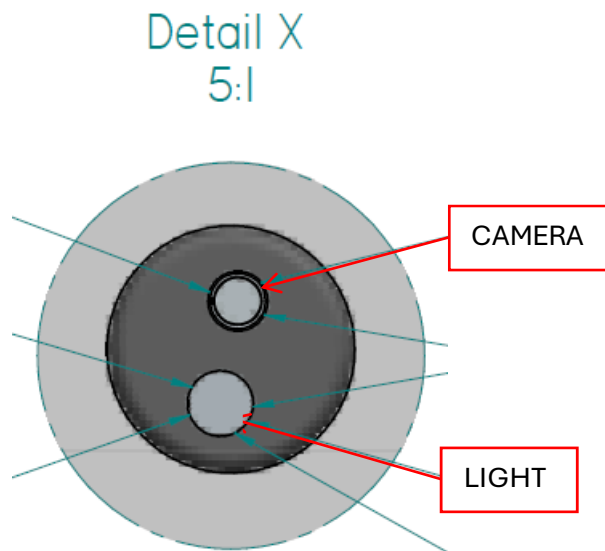
They should also keep in mind that the position of the camera head is not centered in the tip of the 6.5mm diameter flexible portion. This was missing from the presentation. You can see the offset in the screen-snip below ( where it is shown upside down) and the attached picture IMG\_6758, which also shows where the light is positioned (the yellow dot).
